**Work Order ID 70642**

Item Name: Replacement Float Skidtube

DRAWING NO. D3391	TITLE 412 FLOAT SKIDTUBE	REV. H	DART AEROSPACE USA, INC ENGINEERING ORDER		D.E.O. NO. D3391-H-1	SHEET NO. SHEET 1 OF 1	SCALE NTS
DRAWN <i>UP</i>	CHECKED <i>h</i>	MFG. APPR. <i>AA</i>	APPROVED <i>MP</i>		DE APPR. <i>h</i>		
DATE 09.09.23	DATE 09.09.24	DATE 09/09/25	DATE 09/09/30		DATE 09/09/30

# **D3391-043 ASSEMBLY**

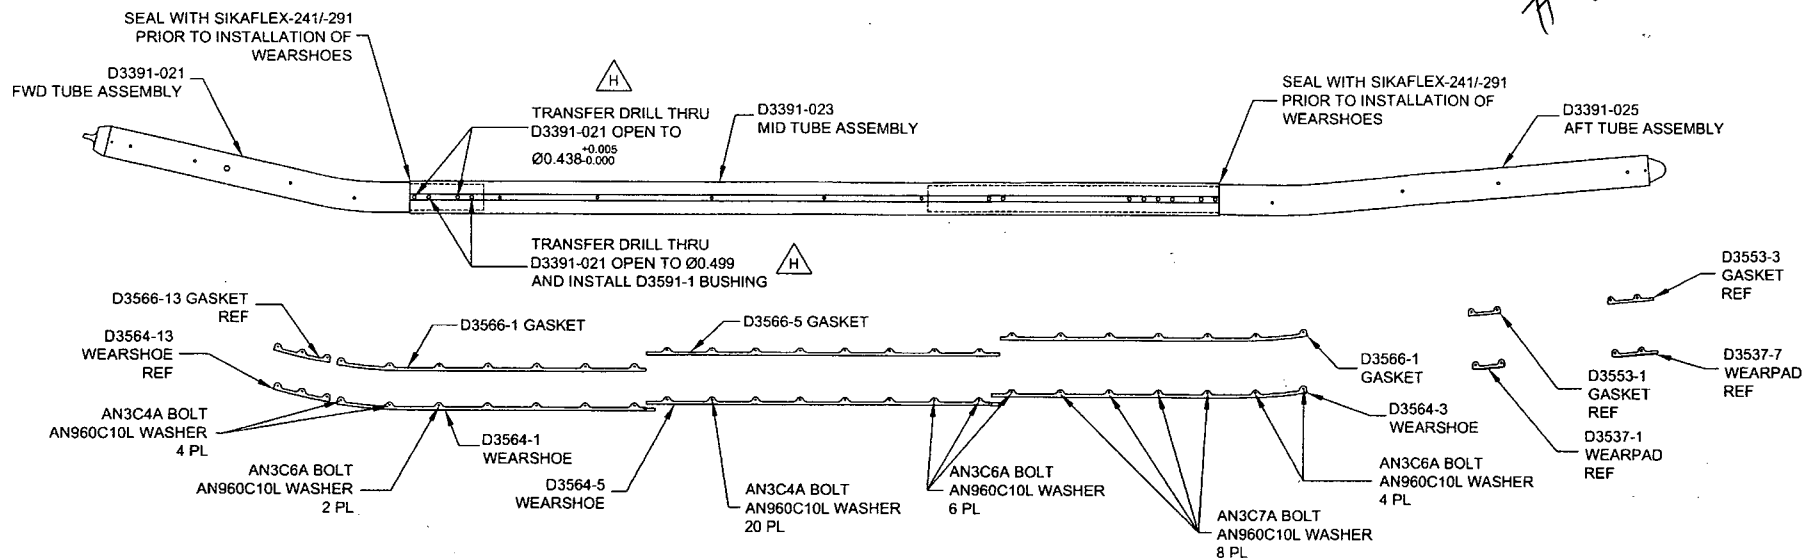
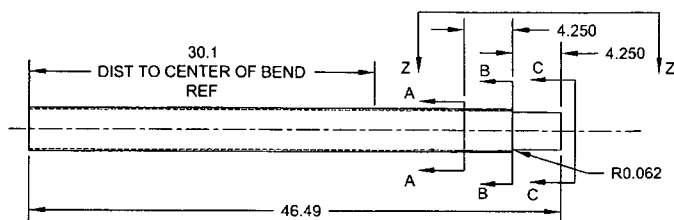
**PURPOSE:**

LPS-3 IS NO LONGER USED DURING ASSEMBLY OF D3391-041/-043 SKIDTUBES.

AMEND NOTE 2 OF D3391-041/-043 SKIDTUBE ASSEMBLIES (ZN A6-1, A6-2) AS FOLLOWS:

- 2) ~~SPRAY INSIDE OF TUBE WITH A COAT OF LPS LABORATORIES "LPS-3" AFTER FINISH~~  
~~AND AFTER INSTALLATION OF INSERTS. COAT ALL EXPOSED FASTENERS WITH~~  
 LPS LABORATORIES "LPS PROCYON" AFTER FINAL ASSEMBLY, CLEAN EXCESS  
 OFF POWDER COATING WITH MEK DEGREASER.
